2SCS1. Sheet SC101M – Moore Middle School - First Floor Plan – Area B – Security

No	Revisions	Date
1	ADDENDUM 2	03/25/16

MOORE MIDDLE SCHOOL - FIRST FLOOR PLAN - AREA B - SECURITY
 SIX BUILDING ACCESS CONTROL INSTALLATION

MOORE MIDDLE SCHOOL - FIRST FLOOR PLAN - AREA B - SECURITY
SCALE: 1/16" = 1'-0"

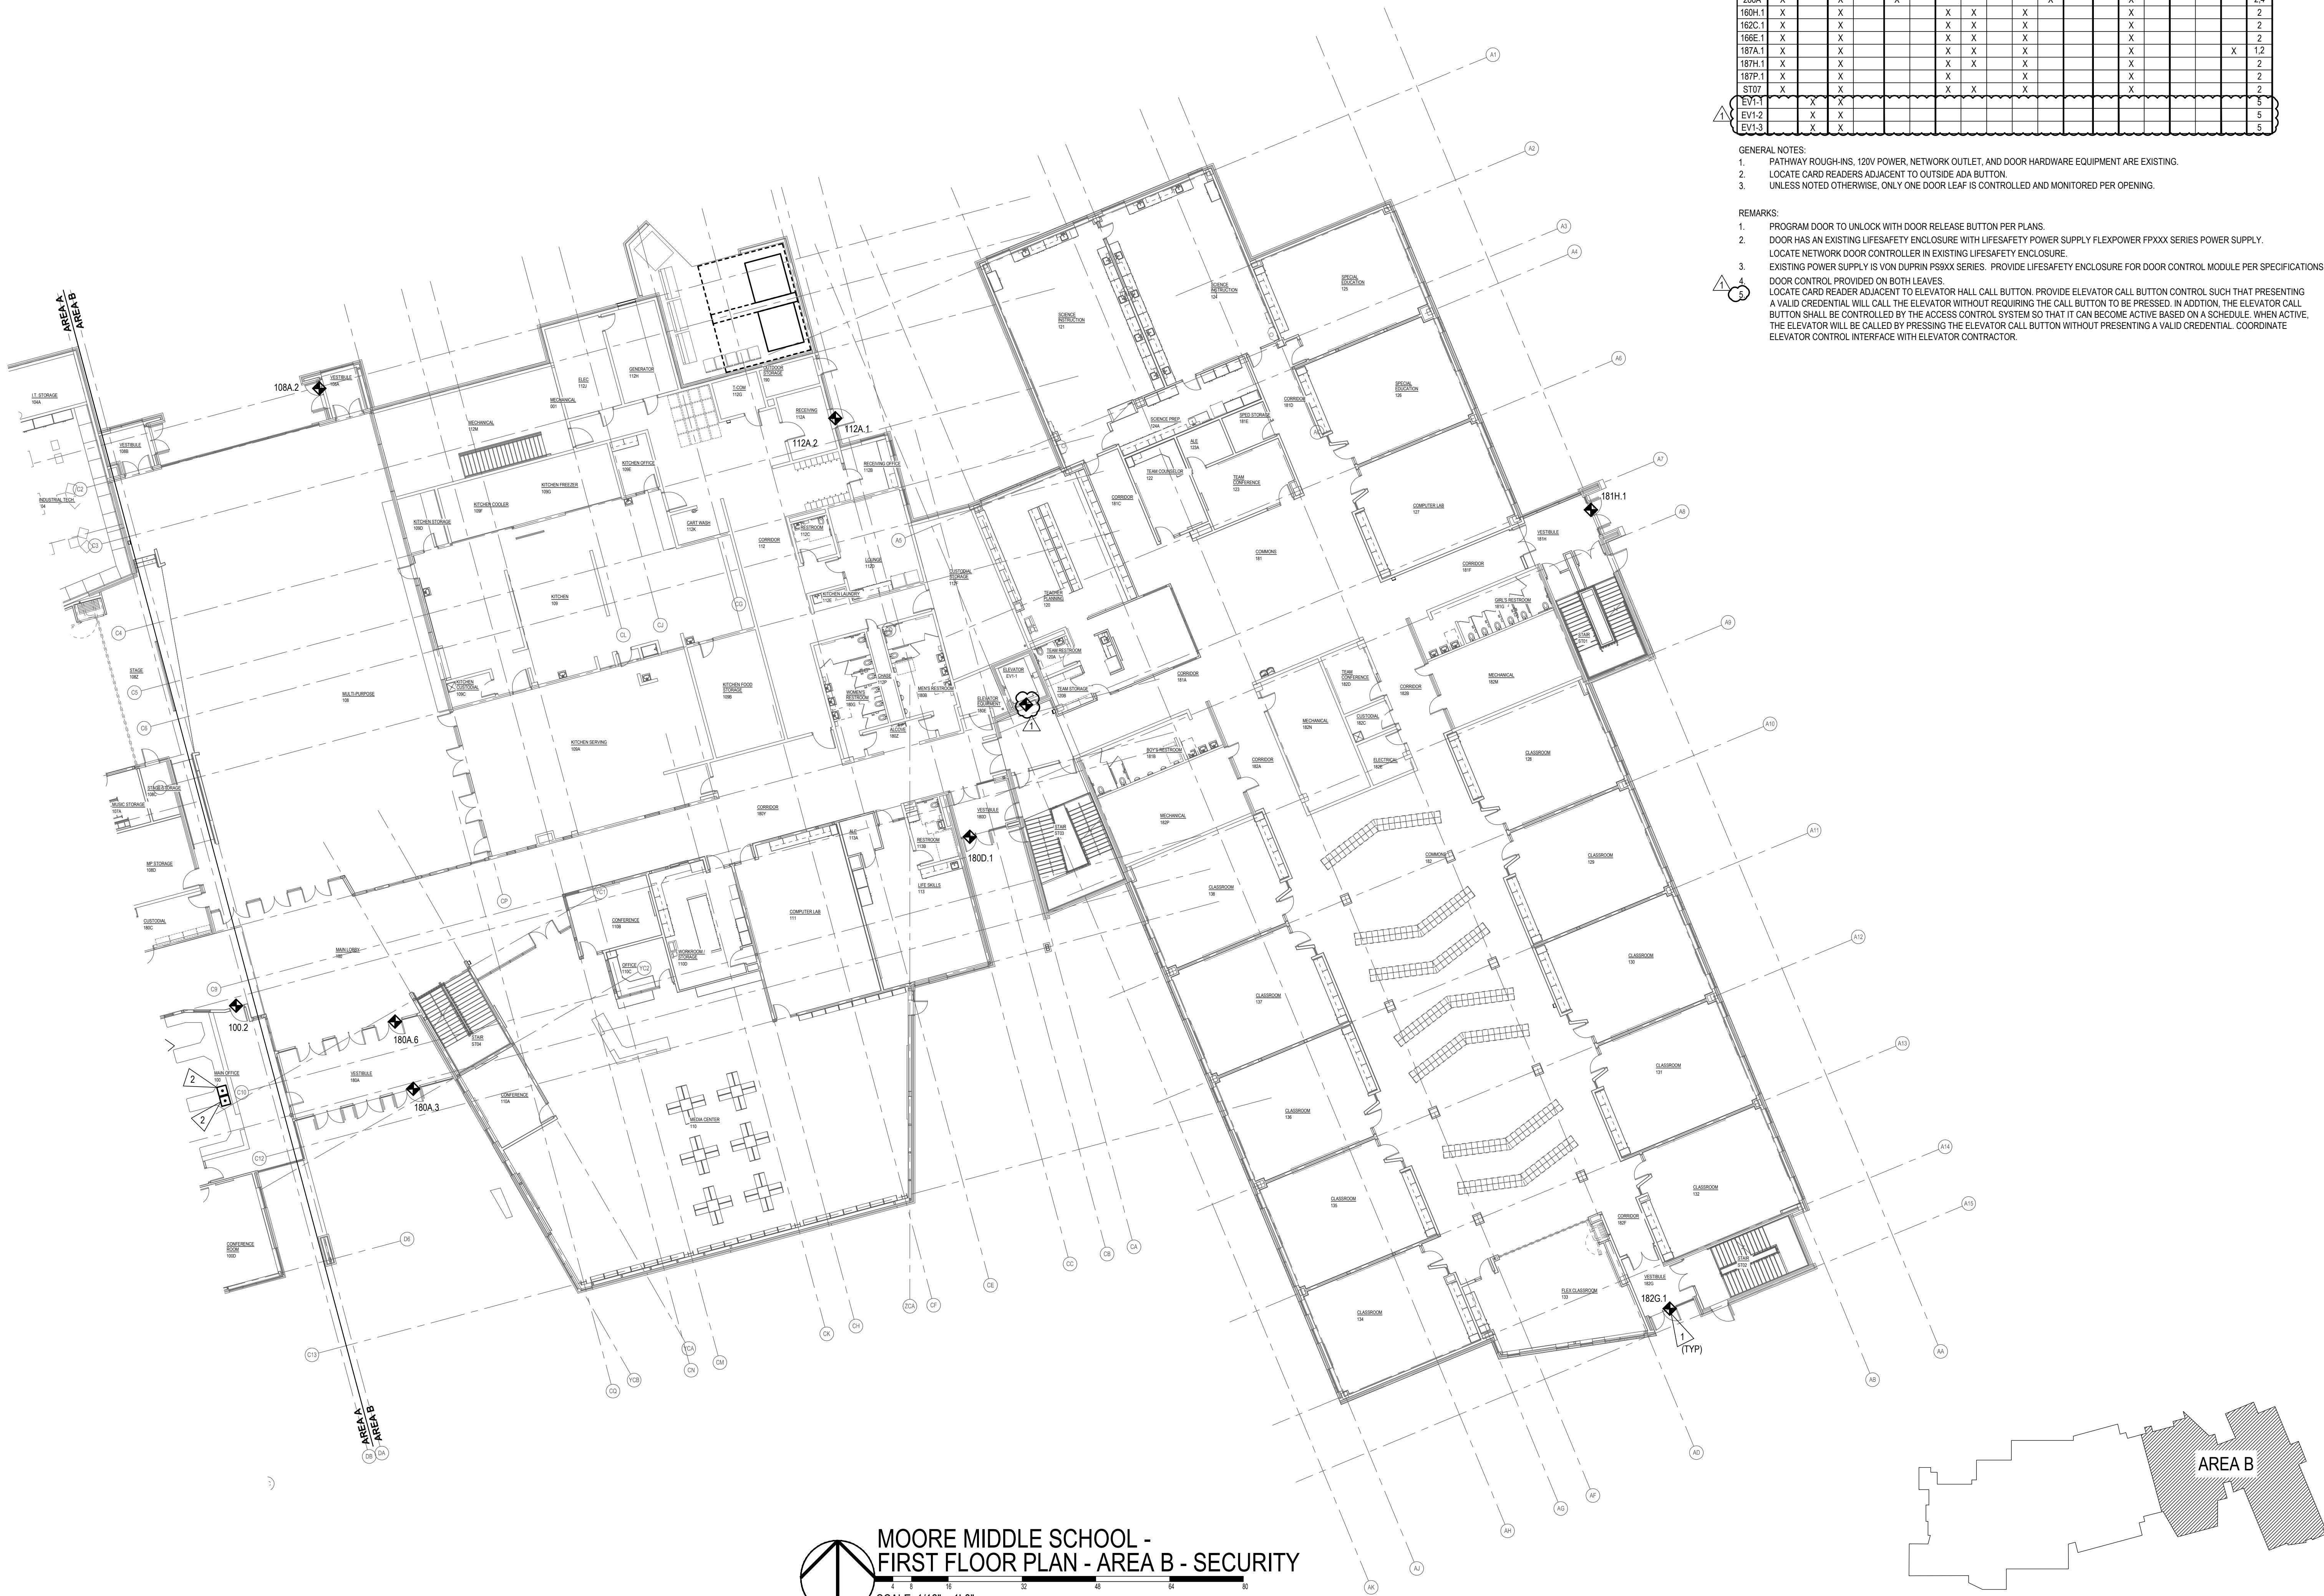
1. Add elevator control per clouded revisions on attached revised drawing.

5. DOOR CONTROL PROVIDED ON BOTH LEAVES.
 6. LOCATE CARD READER ADJACENT TO ELEVATOR HALL CALL BUTTON. PROVIDE ELEVATOR CALL BUTTON CONTROL SUCH THAT PRESENTING A VALID CREDENTIAL WILL CALL THE ELEVATOR WITHOUT REQUIRING THE CALL BUTTON TO BE PRESSED. IN ADDITION, THE ELEVATOR CALL BUTTON SHALL BE CONTROLLED BY THE ACCESS CONTROL SYSTEM SO THAT IT CAN BECOME ACTIVE BASED ON A SCHEDULE. WHEN ACTIVE, THE ELEVATOR WILL BE CALLED BY PRESSING THE ELEVATOR CALL BUTTON WITHOUT PRESENTING A VALID CREDENTIAL. COORDINATE ELEVATOR CONTROL INTERFACE WITH ELEVATOR CONTRACTOR.
